11 JUN 2012
 No: 2012/1142

TITLE: PROPOSED FRONT & SIDE ELEVATIONS
 ADDRESS: 9 WILKINS GREEN LANE HATFIELD, ALTO 9RT
 CLIENT: Mr. & Mrs TITMUSS
 SCALE: 1:100 @A3
 DATE: MAY 2012
 DRAWING No: WGL 102-5

No 9. use this picture to demonstrate their unsightly view of No. 8

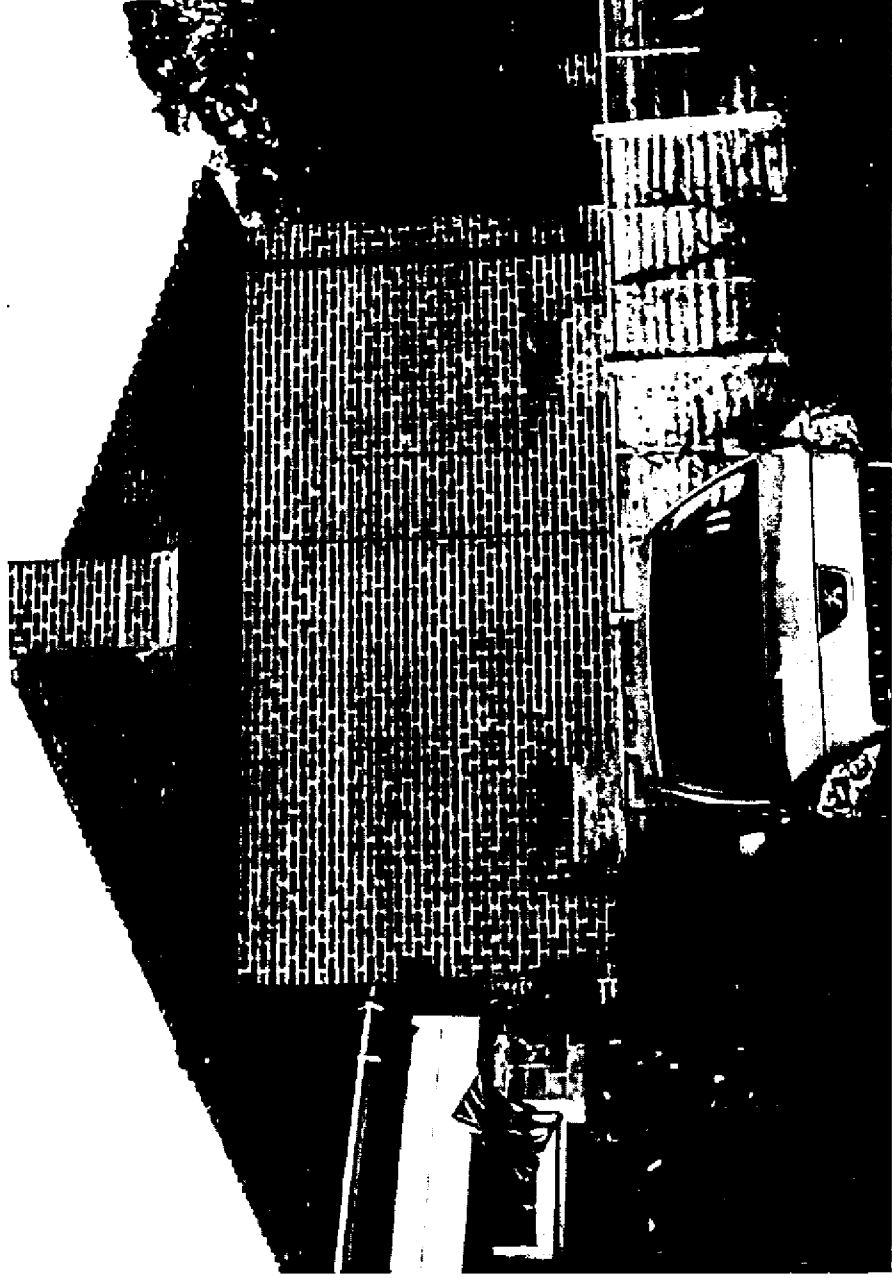
- They will be giving us a much larger expanse of bricks without a roof
- The mature trees that screened this view were removed by No. 9 shortly after they moved in, possibly to avoid any root protection issues with their proposed build

No. 9 use this view to demonstrate the additions to our home

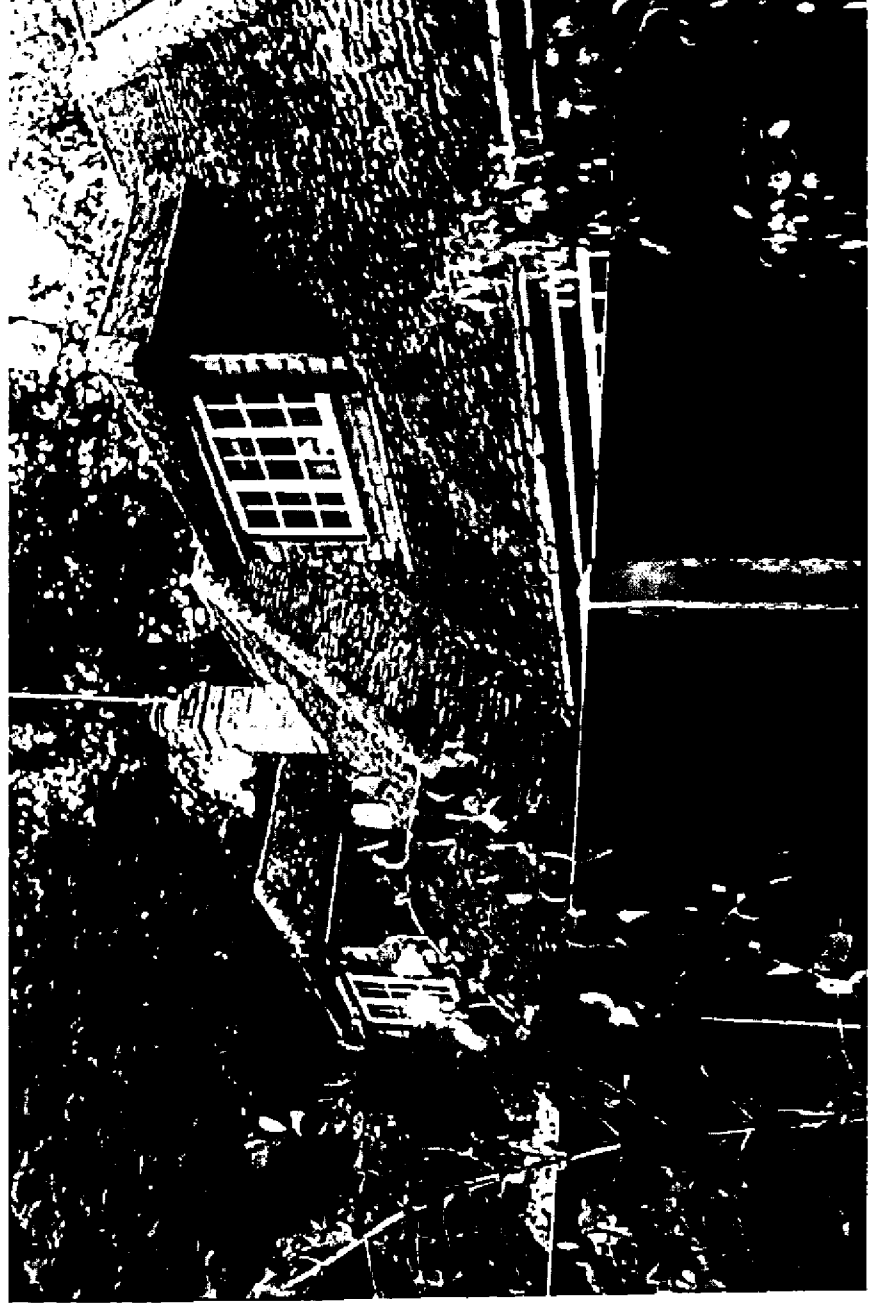
- This point is irrelevant as these dormers were in place before No. 9 was built
- These are the features of a chalet bungalow, the covenant in place to protect No. 10 prohibit anything other than a bungalow for No. 9
- The proposed second floor of No. 9 does not qualify as a chalet bungalow as they do not sit within the roof eaves

No. 9 use the images below to show all issues they dislike about their new home

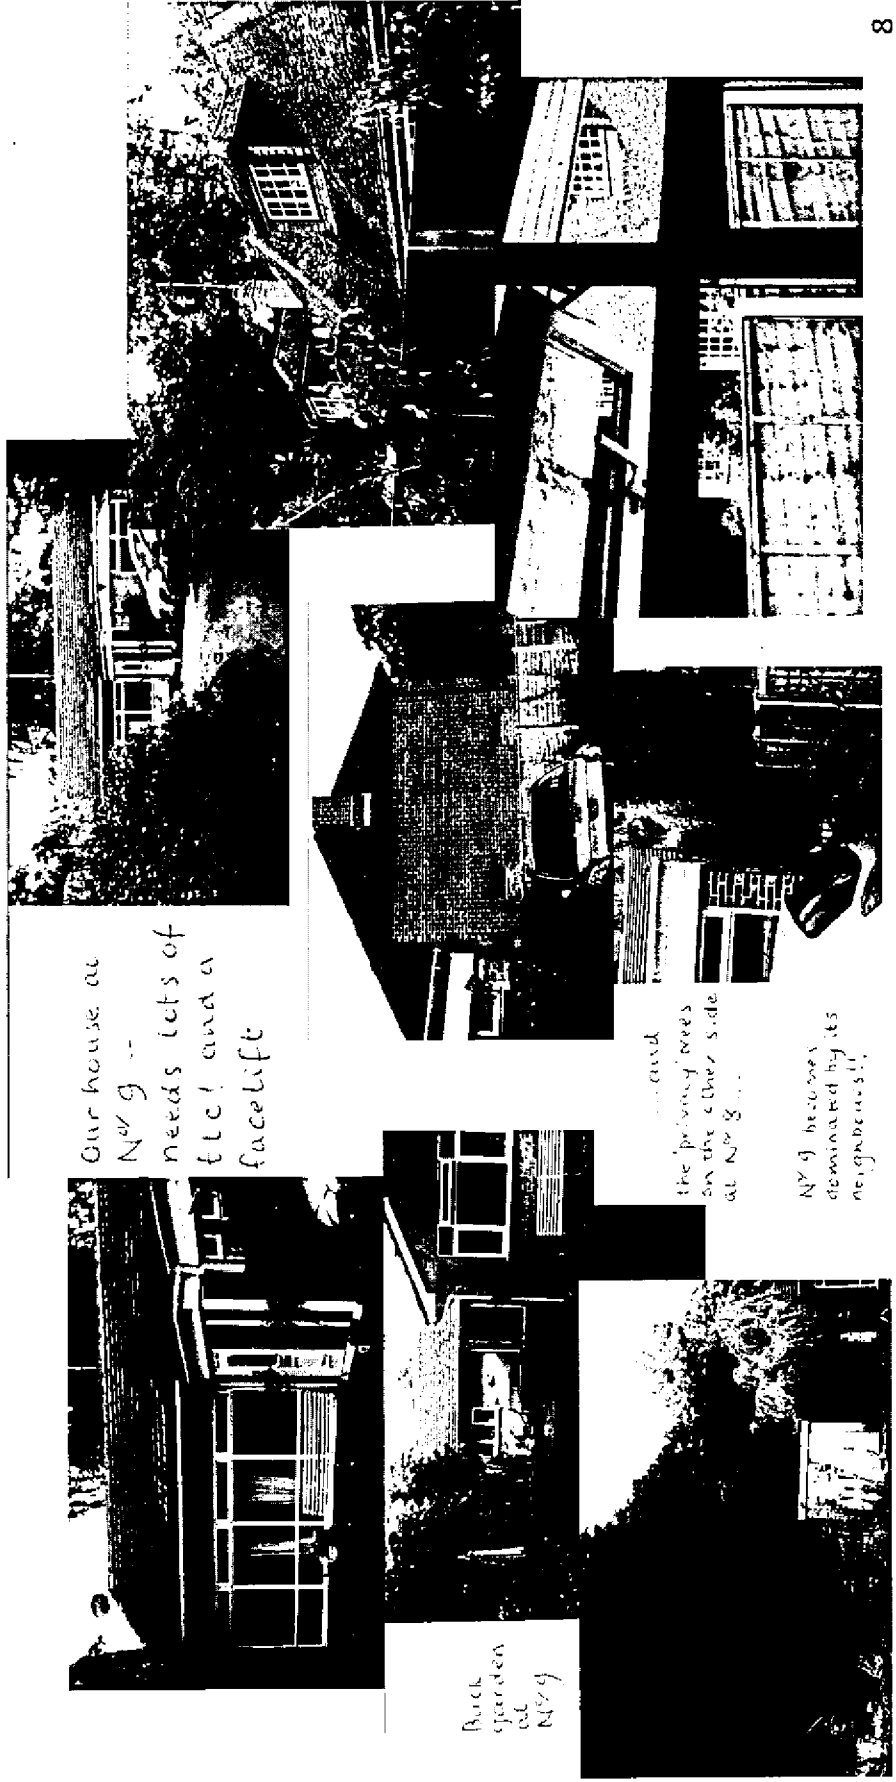
- They purchased the property fully aware of all these issues
- The proposed build does nothing to resolve any of them, it only creates new ones

SIDE ELEVATION FROM No 10

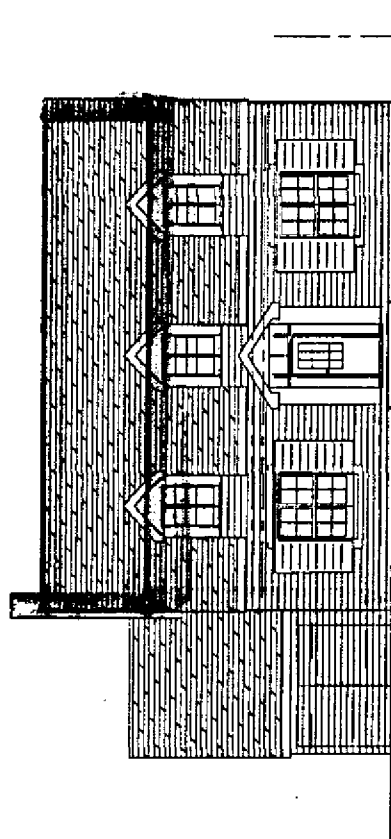
290% increase in area

ROOF PLAN

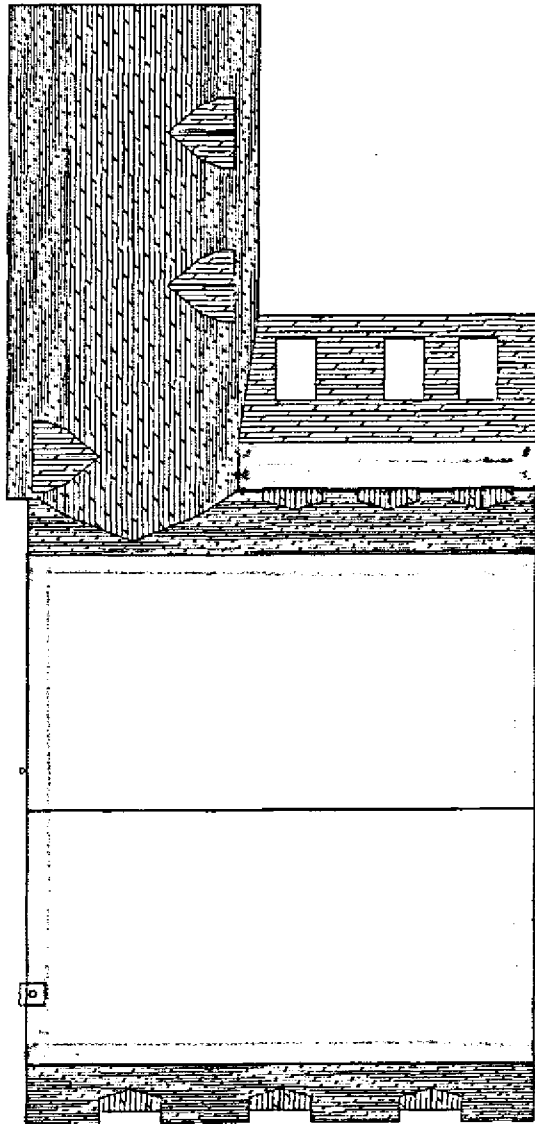
Flat roof area = 41% of total roof area

Flat roof area = 152 m²

SIDE ELEVATION FROM No.8

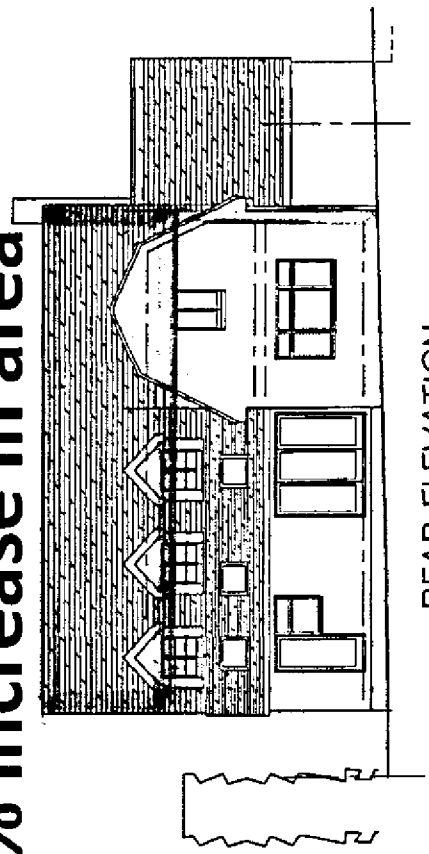
246% increase in area

GROUND FLOOR PLAN

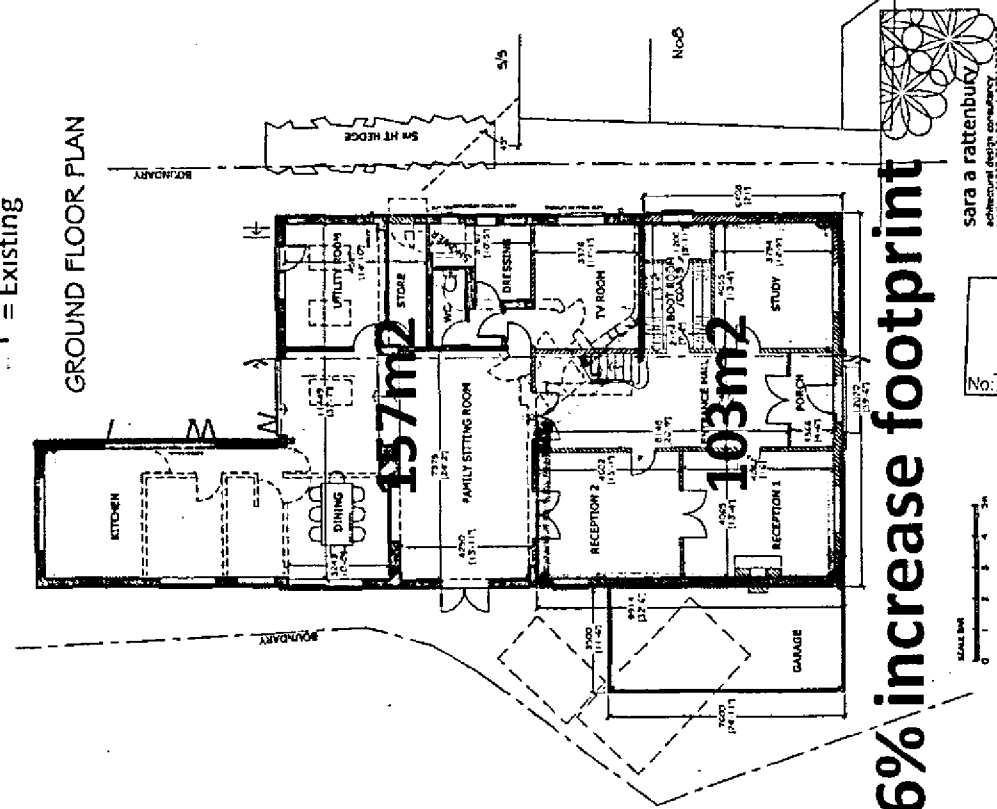
66% increase footprint

FIRST FLOOR PLAN

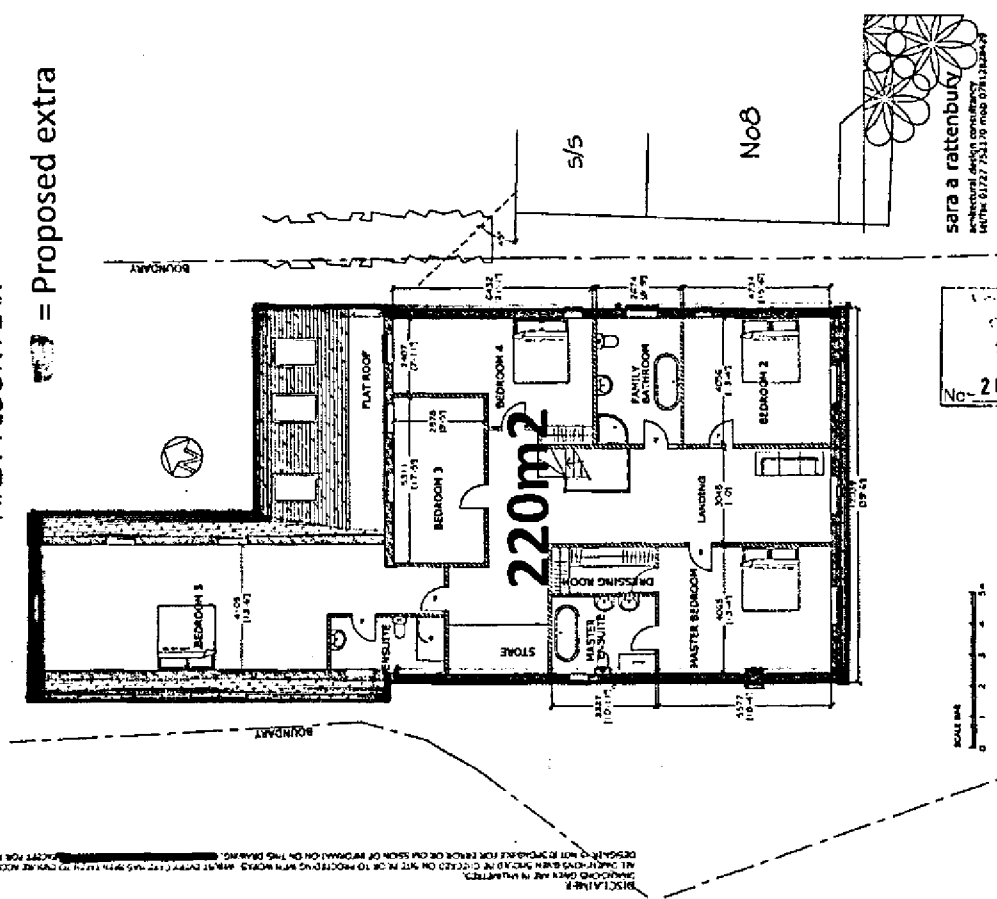
Total Proposed 476m² (5,049 sq ft)

which is a 308% increase
